# UNITED STATES PATENT AND TRADEMARK OFFICE

APPLICATION NO.	FILING DATE	FIRST NAMED INVENTOR	ATTORNEY DOCKET NO.	CONFIRMATION NO.
10/524,185	10/11/2005	Kerry D Hinson	60680-2004	2663

<b>Office Action Summary</b>	<b>Application No.</b> 10/524,185	<b>Applicant(s)</b> HINSON ET AL.	
	<b>Examiner</b> Zelalem Eshete	<b>Art Unit</b> 3748

## DETAILED ACTION

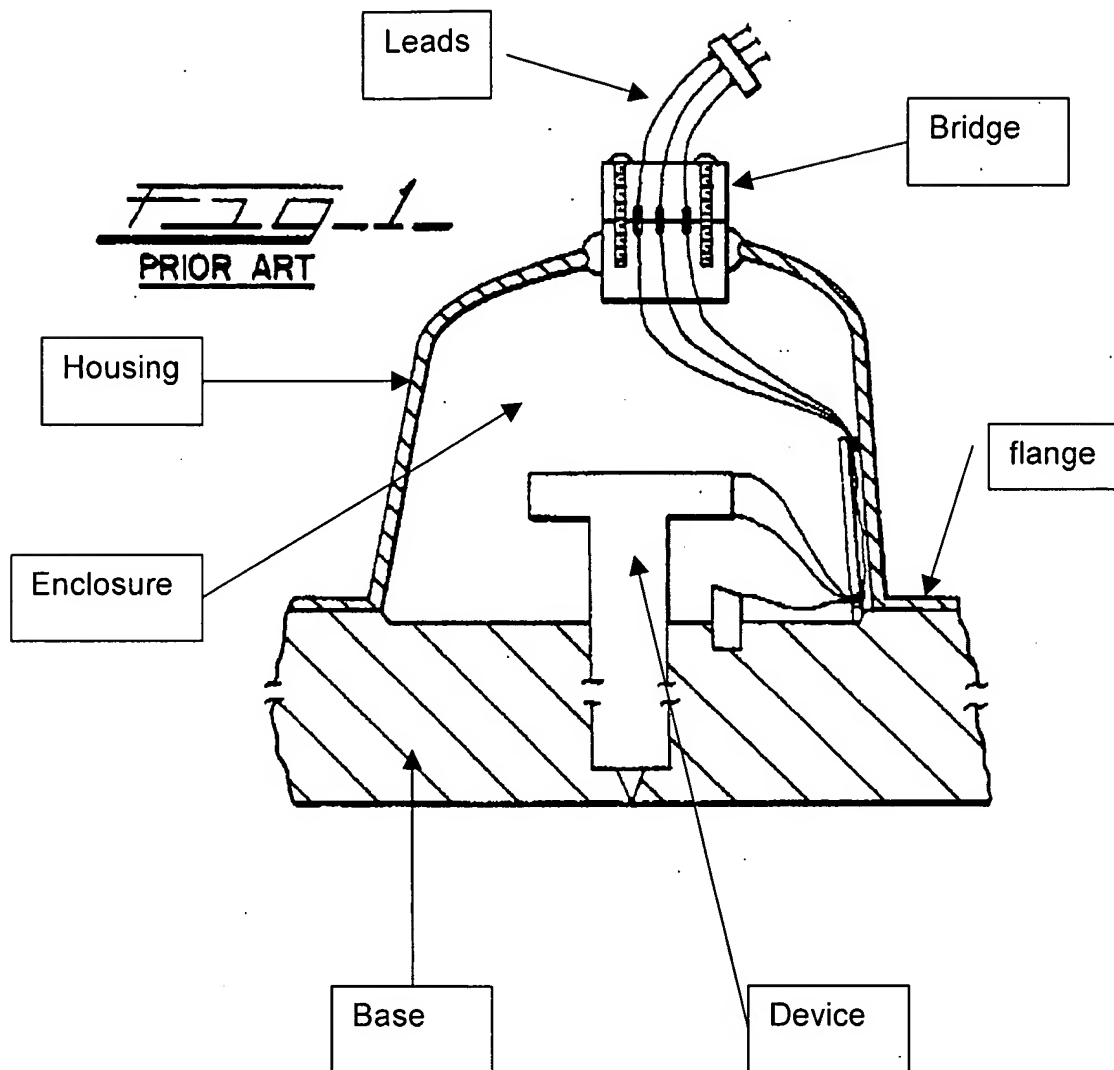
4. Claims 1-5 are rejected under 35 U.S.C. 103(a) as being unpatentable over Mathew et al. (5,035,637) in view of Santella (5,375,569).

Regarding claims 1,3: Mathew discloses a cover with an electrical bridge comprising a base component; a housing mounted to the base component defining an enclosure therein; at least one electrical connector integrally formed with the housing, the at least one electrical connector including one or more electrical leads integrally formed with the housing that extend through the housing for allowing electrical energy to pass from an electrical source outside the housing to an electrical device within the enclosure, thereby forming an electrical bridge between the electrical source and the electrical device (see labeled figure below).

Regarding claim 7: Mathew as modified above discloses the housing comprises a bottom "pan" flange (see labeled figure above).
